UNITED STATES PATENT AND TRADEMARK OFFICE

Office Action Summary

10/629,043

DETAILED ACTION

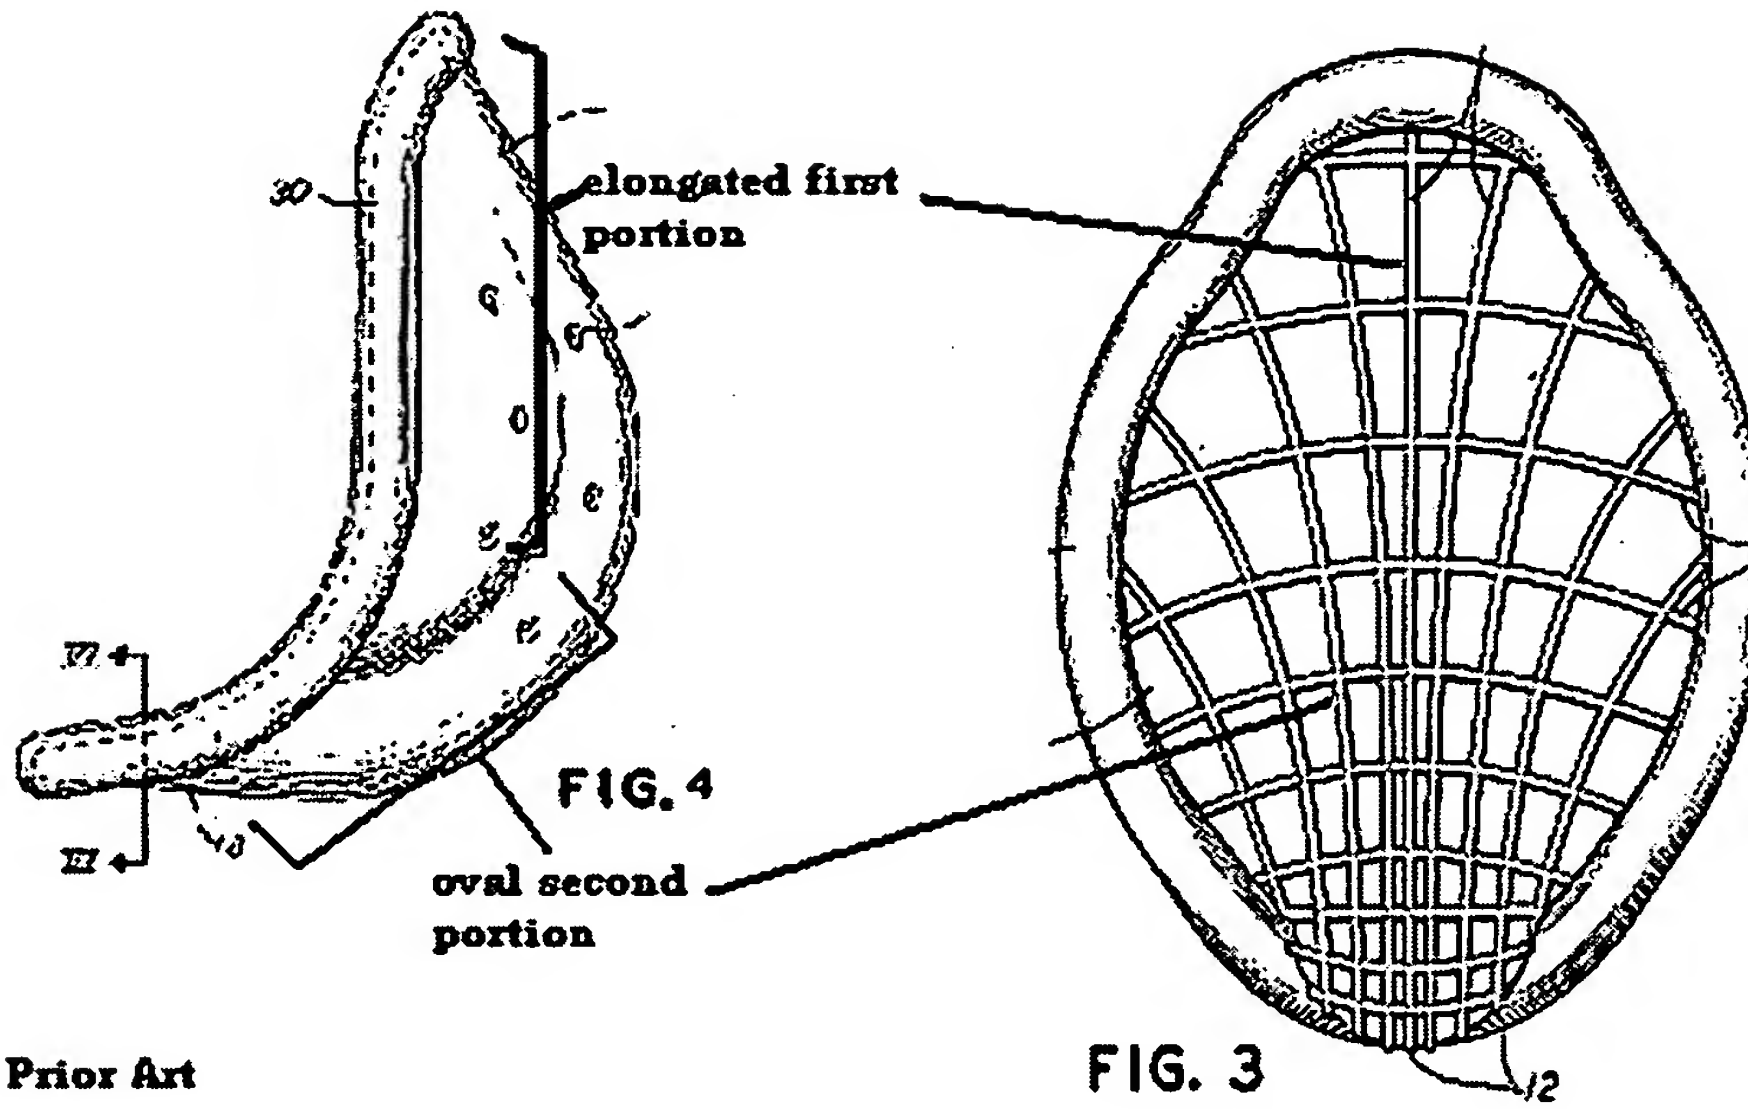
5. As to claim 1, DiMatteo discloses a system for protecting a male genital region from injury in addition to providing comfort to a wearer (see col.2 lines 62-67, col.3 lines 1-2) including a cup (see fig.1 reference object 10) with elongated first and oval second portion (see labeled figs. 3 and 4, attachment

below), however does not disclose the first portion substantially conforms to a penis; and the second portion substantially conforms to a male scrotum. However, DiMatteo teaches the protective cup having a convex outer surface, and a concave inner surface with sufficient volume to enclose a wearer's male genitals (see col.3 lines 20-24). Therefore, it would have been obvious to one of ordinary skills in the art at the time of the invention the concave nature of the first portion and second portion of DiMatteo's cup is capable of conforming to a penis and a male scrotum respectively for the purposes of securing the genitals in position and further allowing comfort to a wearer.

6. **As to claim 2, DiMatteo discloses** the protective device of claim 1 wherein said first portion is positioned above said second portion (see figs. 3 and 4, the elongated top portion is positioned above the oval bottom portion).

7. **As to claim 3, DiMatteo discloses** the protective device of claim 1 further comprising a flange (extension rod with finger like projection) positioned (see fig.5 reference object 16) at the lower end of the protective device (lower end of the oval portion, see labeled figs.3 and 4), **however does not disclose the flange facilitates securing the protective device to the male body to minimize horizontal and vertical movement.** Notice, however, the finger like extension is designed to extend between the wearer's upper thighs, and engage his body proximate to the superior ramii, the inferior ramii, and/or the Ischial ramii of the pelvis with minimal contact with the upper thigh (see col.6 lines 23-27). Additionally, the rod is larger dimension in the vertical direction as opposed to the horizontal direction (see col.6 lines 38-41). The position and the size of the exertion rod with finger like projection inherently capable of preventing the cup from dislodging by minimizing horizontal and vertical shifts. Therefore, it would have been obvious to one of ordinary skills in the art at the time of invention that a flange or a finger like extension of a cup that is long
